APPLICATION NO.	FILING DATE	FIRST NAMED INVENTOR	ATTORNEY DOCKET NO.	CONFIRMATION NO.
10/771,603	02/04/2004	Sung-Bum Park	5000-1-511	3429
33942	7590	08/01/2007		
CHA & REITER, LLC 210 ROUTE 4 EAST STE 103 PARAMUS, NJ 07652			EXAMINER LIU, LI	
			ART UNIT 2613	PAPER NUMBER
			MAIL DATE 08/01/2007	DELIVERY MODE PAPER

Office Action Summary	Application No. 10/771,603	Applicant(s) PARK ET AL.	
	Examiner Li Liu	Art Unit 2613

DETAILED ACTION

Fig. 5(b)

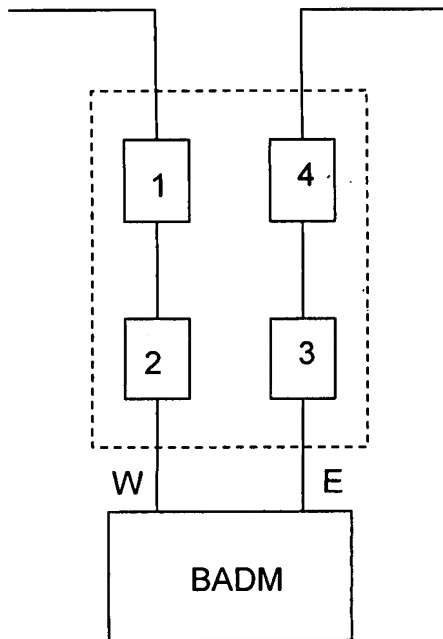
With regard to item (B), the applicant actually uses a "cross/bar" switch. The Figures 5(b) and 5(c) of applicant can be plotted as:

The cross/bar switch is well known and widely used in the art. Oberg et al teaches a bidirectional add/drop multiplexer and uses a cross-bar switch (Figures 4, 6-12) for performing a switching operation to connect a first port to a second port and a third port to a fourth port in case of a normal state and to connect the first port to the third port and the second port to the fourth port in case of system failure so that the optical signal having higher priority can be recovered first (Oberg et al: ABSTRACT; [0070]-[0073]).

But, in Oberg's system, the cross-bar switch is connected to the one fiber line via the add/drop filter 27w and 27e, the switch is not directly connected to the one fiber line.

However, where the switch is putted is just a design choice, as long as the switch can perform the operation so that the network is self-healing and the optical signal having higher priority can be recovered first.
